- 1. Clam Gulch Heights 2022 Addition; KPB File 2022-136
Johnson Surveying / Wann Family Trust, Ciccone
Location: Ciccone Street & Russel Avenue
Clam Gulch Area**

Clam Gulch Heights 2022 Addition

Preliminary Plat

STAFF REPORT

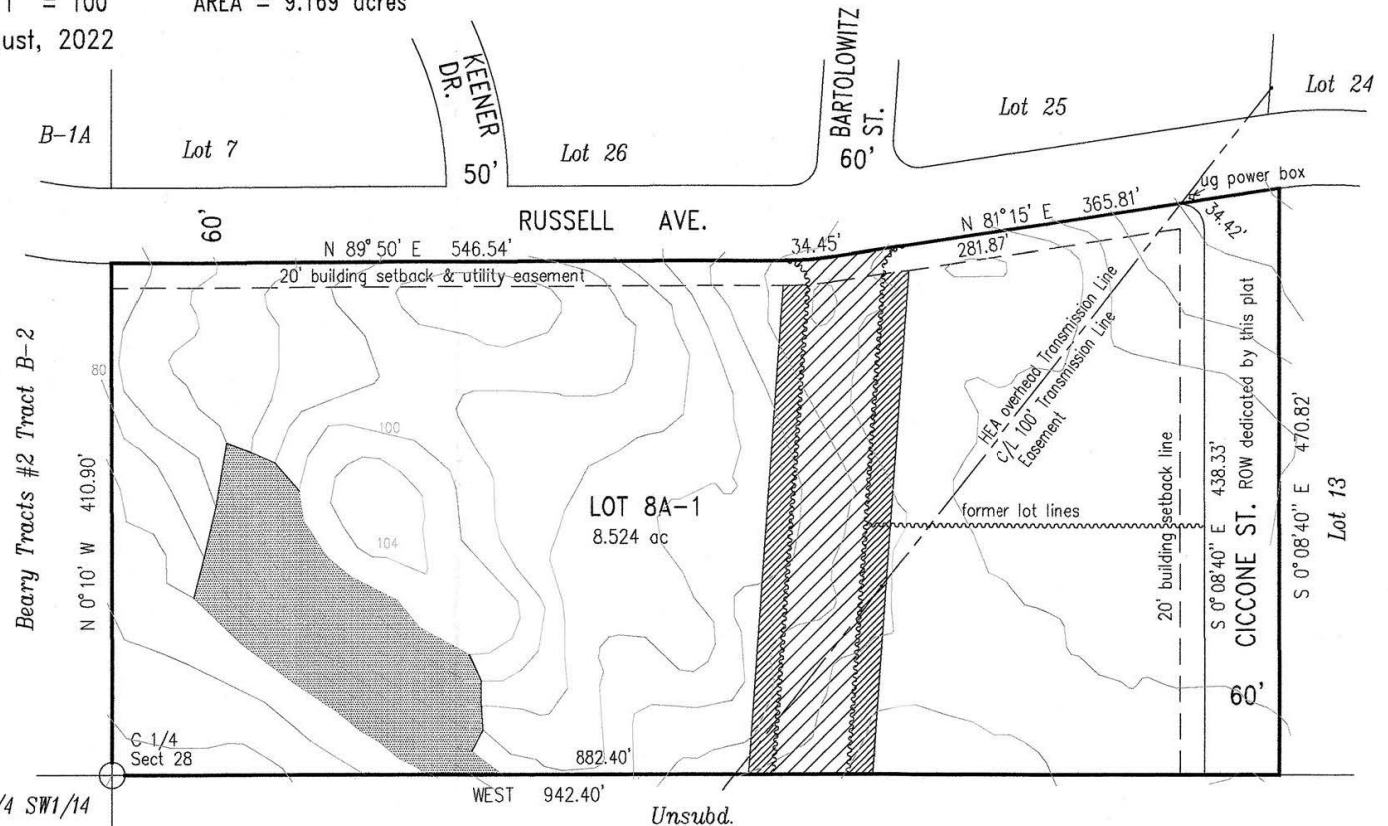
Street includes the utility easements as shown on the plat. The plat will have a 20 foot utility easement along Russell Avenue within the former right-of-way. The plat does not indicate the utility easement intention along the new dedication. Code only requires 10 foot utility easement. **Staff recommends** the easement along the western boundary be depicted and labeled as being granted by Plat KN 72-61, the 20 foot utility easement along Russell Avenue be labeled as being granted by Plat KN 81-135, note that the transmission easement was granted by Plat KN 72-61, and either add to the description along the new dedication "and utility easement granted by this plat" or depict a 10 foot utility easement with a label "granted by this plat".

The plat was submitted to the utility providers for comment. Homer Electric Association noted that there is an existing overhead line within the southwest corner of the subdivision and requested a 30 foot easement centered on existing line including guy anchors. **Staff recommends** the line be located and depicted with the easement being granted as requested and noted that it is "granted by this plat."

ACS stated they did not approve of the proposed vacation of utility easements adjacent to the dedication as they currently have equipment within that area. They stated they can be moved but at the owner's expense. **Staff recommends** the owner works with ACS for a resolution that could include leaving the utility easement, granting of new easements, or relocation of equipment and written confirmation from ACS must be submitted that they agree prior to finalization of the plat.

- Staff recommendation:** In the first line of description, add a space between 12 and 13. Remove "17, 18 (KRD 81-135)" from the third line.
- D. A vicinity map, drawn to scale showing location of proposed subdivision, north arrow if different from plat orientation, township and range, section lines, roads, political boundaries, and prominent natural and manmade features, such as shorelines or streams;

- Staff recommendation:** Update C.G. Road to spell out the road or use a leader. Staff could not find confirmation of Russell Lake.
- G. The status of adjacent lands within 100 feet of the proposed subdivision boundary or the land status across from any dedicated rights-of-way that adjoin the propose subdivision boundary, including names of subdivisions, lot lines, block numbers, lot numbers, rights-of-way; or an indication that the adjacent land is not subdivided;

- Staff recommendation:** Update the labels for the lot to the west.

Within plat note 1, correct the parent plat number.

Within plat note 2, correct the spelling of utility.
